To: Development Permit Panel

File: DP 16-740024  
HA 16-744661

Re: **Application by Tien Sher Chatham Development Ltd. for a Development Permit and Heritage Alteration Permit at 3755 Chatham Street**

PROJECT	16-UNIT COMMERCIAL MIXED-USE BUILDING
	3735 / 3751 / 3755 / 3771 Chatham Street Richmond, B.C.
PROJECT NO.	1424CHTM
SCALE	AS NOTED
DATE	MARCH 23, 2016
DRAWN BY	KYC, RS, VT
CHECKED BY	KYC
SHEET TITLE	THIRD FLOOR PLAN, ROOF TOP FLOOR PLAN, EAST & WEST ELEVATION
DRAWING

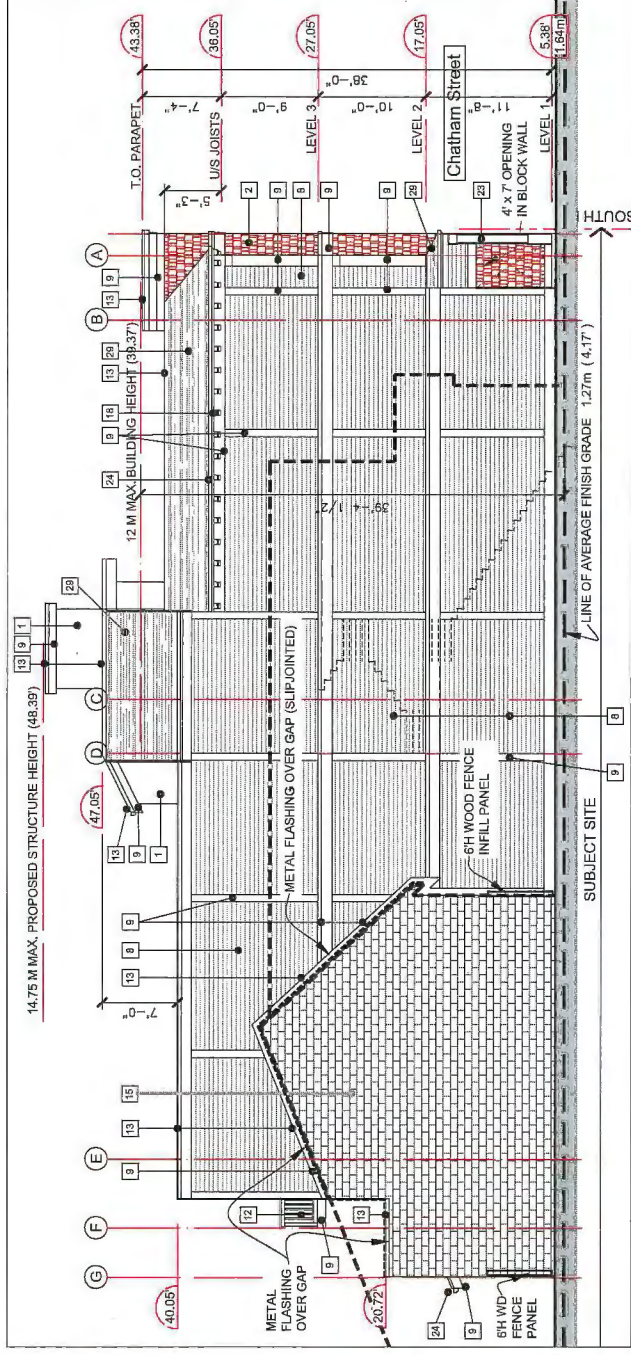
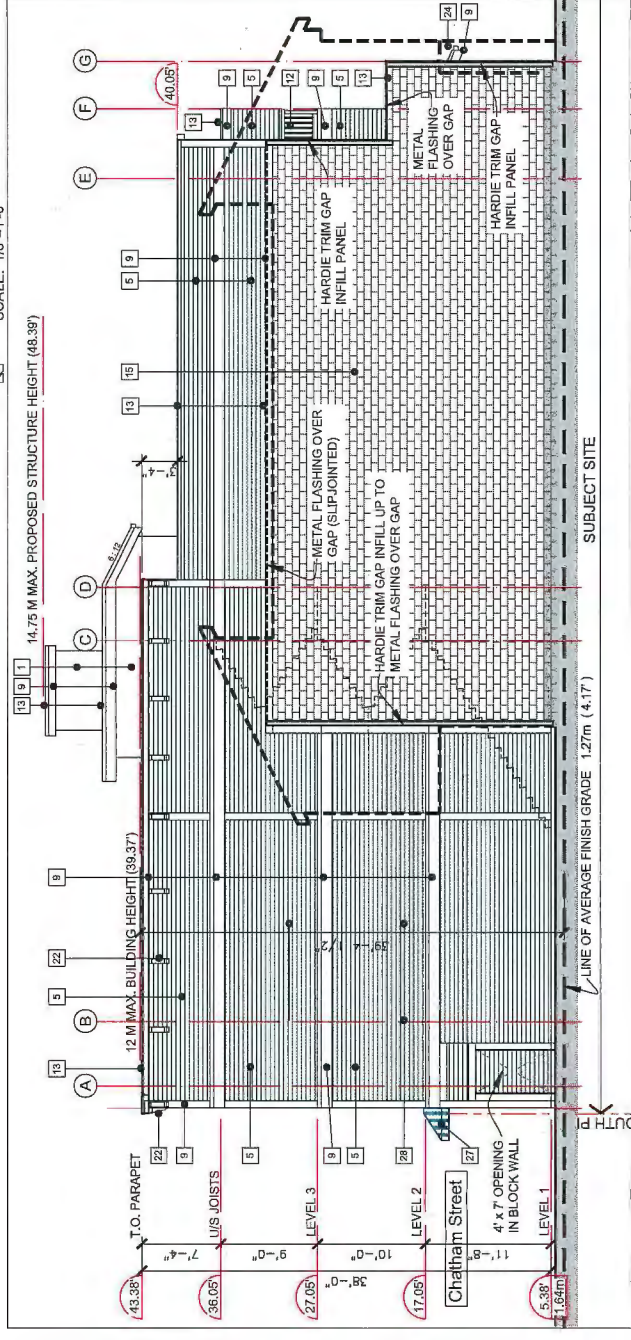
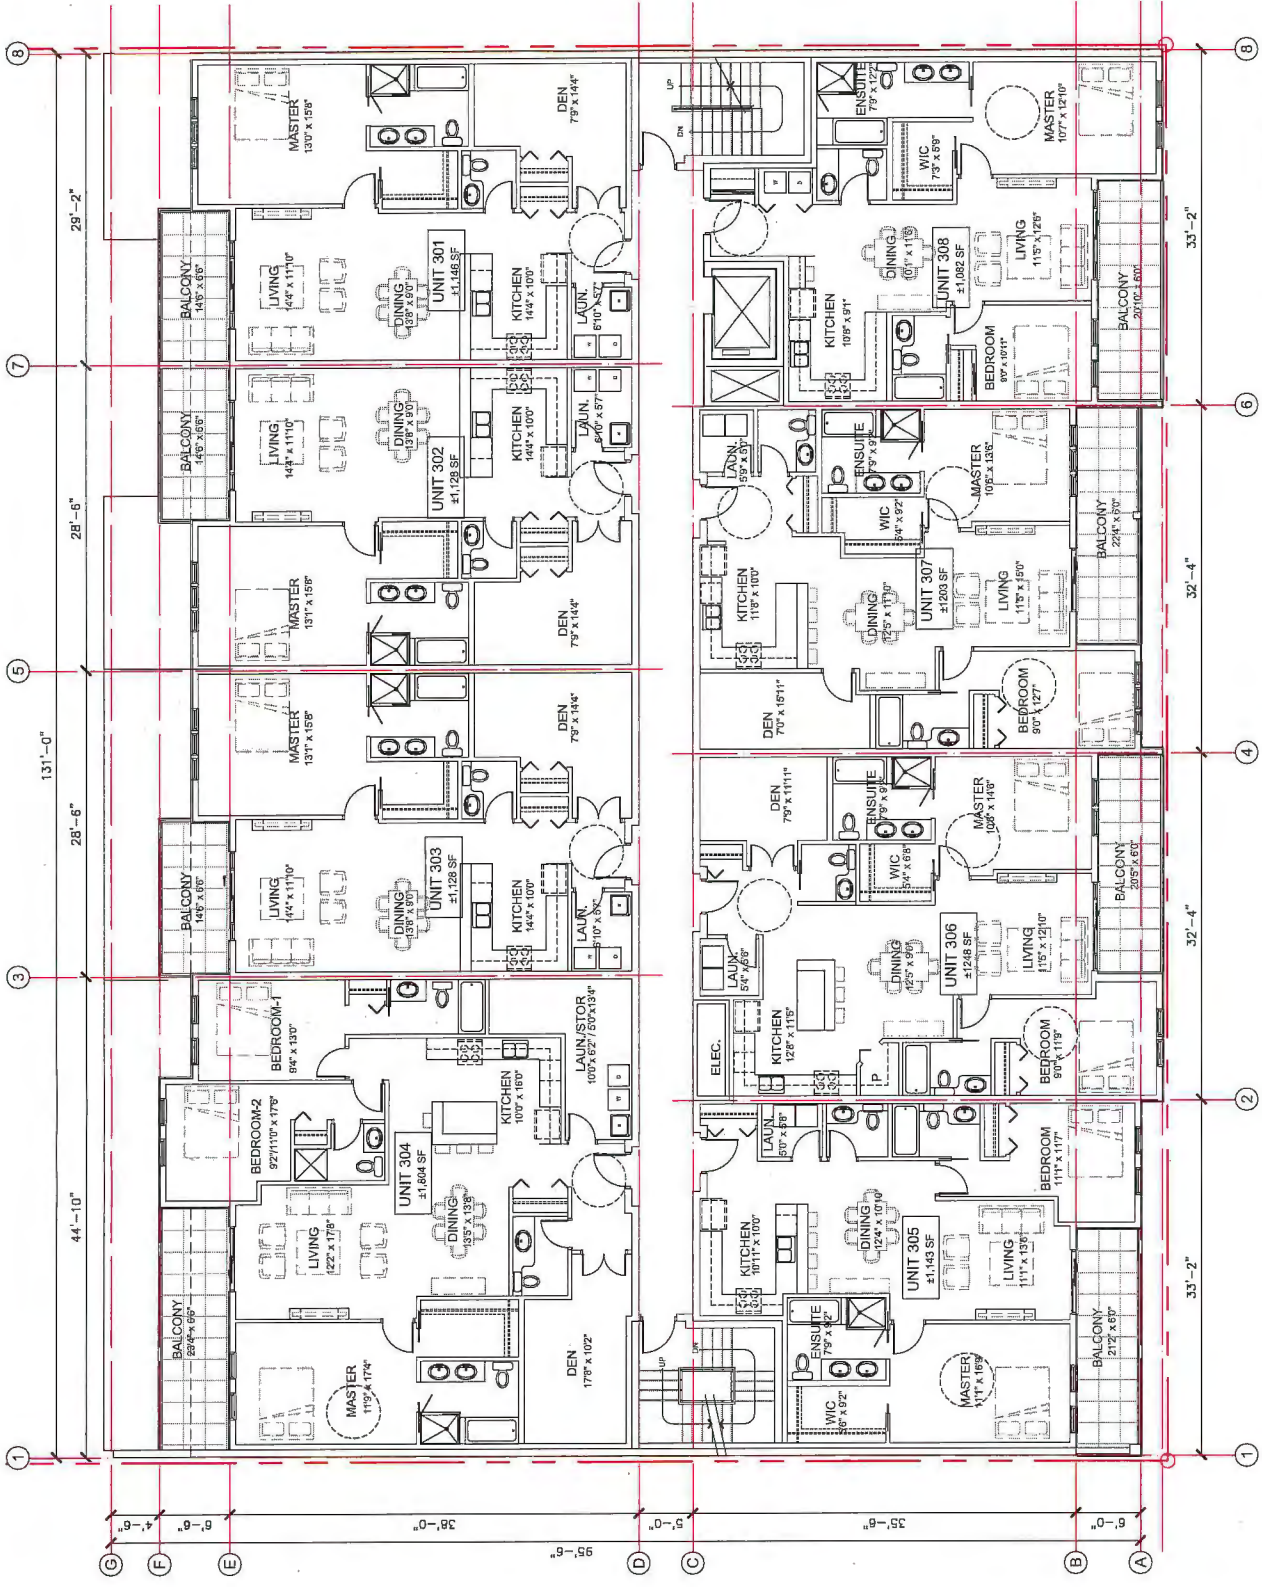
- agree with the applicant's approach not to introduce windows on the zero lot line wall at the west elevation of the proposed building; *No change.*
- consider rain and snow screening for the narrow space between the east and west zero lot line walls of the subject development and the walls of adjacent developments on both sides; *East (at medical building): Install metal flashing over (slipjointed) gap (approx 8"), anchored to taller building; vertical gaps entirely covered with Hardipanel material to match new building. West (at 'church'): Install metal flashing, anchored to new building, slipjointed over existing sloped church gabled roof at gap (approx 8"); at vertical gaps, install 6'H section of cedar fence to prohibit pass-thru between buildings (approx 2-ft).*

- appreciate the proposed cladding treatment to the west zero lot line wall; however, also consider introducing public art, e.g. a mural, on the west elevation; *Have resolved to fully clad end walls, but dropped idea of permanent wall anchors for future art. Ideas for photographs/mural/artwork were considered for both west and east end walls, but after consideration by both Planning and the owner, it was felt that there would be a lack of agreement on the specific details. As well, our suggestion for permanent wall anchors for future banner mounting may result in their use for unintended non-public (i.e. commercial) purposes.*

- agree with the suggestion to introduce murals on the west and east elevations of the proposed building; *Ideas for photographs/mural/artwork were considered for both west and east end walls, but after consideration by both Planning and the owner, it was felt that there would be a lack of agreement on the specific details. As well, our suggestion for permanent wall anchors for future banner mounting may result in their use for unintended non-public (i.e. commercial) purposes.*
- review the termination of the parapet at the west elevation and clarify the design of the mansard roof; and *To simplify roof roofs, the sloping south portion of the mansard roof has been flattened.*
- consider increasing the height of the 4 feet by 7 feet side opening of the building to meet up with the front façade. *Will look to raise during BP docs stage.*

*The west exterior end wall will be clad with the same non-combustible fibre cement siding and trim as the south frontage (i.e. the 1st section). The exterior cladding will cover the end wall right up to the outline of the existing church building (which is 8" to 24" away from common property line. (Clarification: the section left unclad will be the 'shadow' of church as it would appear if the church building was 'extended' into the new building. Initially, a banded split-faced concrete block finish was proposed, followed by discussions of the above-mentioned options as well as the current church owner's suggestion for a blank wall to serve as an occasional projection surface for his own commercial purposes. Ideas for photographs/mural/artwork were considered for both west and east end walls, but after consideration by both Planning and the owner, it was felt that there would be a lack of agreement on the specific details. As well, our suggestion for permanent wall anchors for future banner mounting may result in their use for unintended non-public (i.e. commercial) purposes.*

PROJECT	16-UNIT COMMERCIAL MIXED-USE BUILDING
SCALE	AS NOTED
DATE	MARCH 23, 2016
DRAWN BY	KYC, RS, VT
CHECKED BY	KYC
SHEET TITLE	ROOF TOP FLOOR PLAN, PERSPECTIVE VIEWS
DRAWING	A2.4

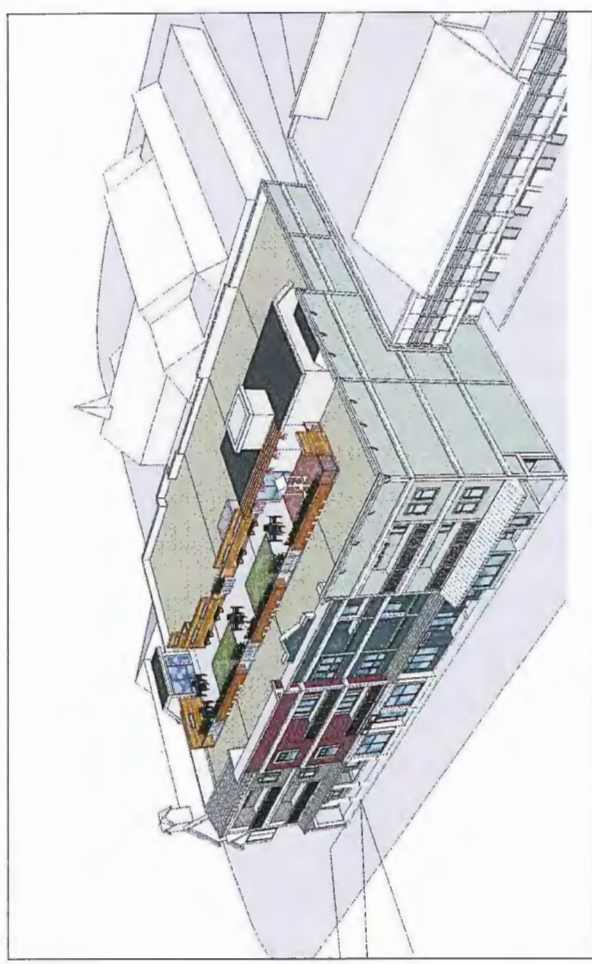
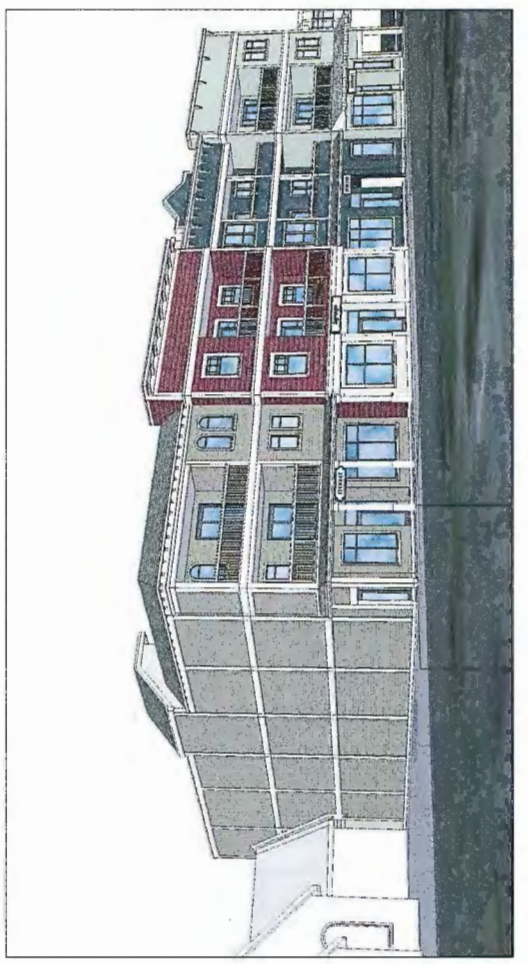
- the siting of the small storage area for garden tools on the rooftop is tricky; consider adjusting the position of the door to provide an easier and more efficient access; *East rooftop stair enclosure now replanned to flow better.*

- appreciate the proposed rooftop outdoor amenity area and support the proposed building height variance; *Elevator structure overrun retained, but trellises over raised planters have been deleted.*

- appreciate the use of glazing on one side of the projecting stair shaft on the rooftop; consider introducing glazing to the other side to allow natural sunlight to the corridors below; *Similar glazing added to west enclosure.*
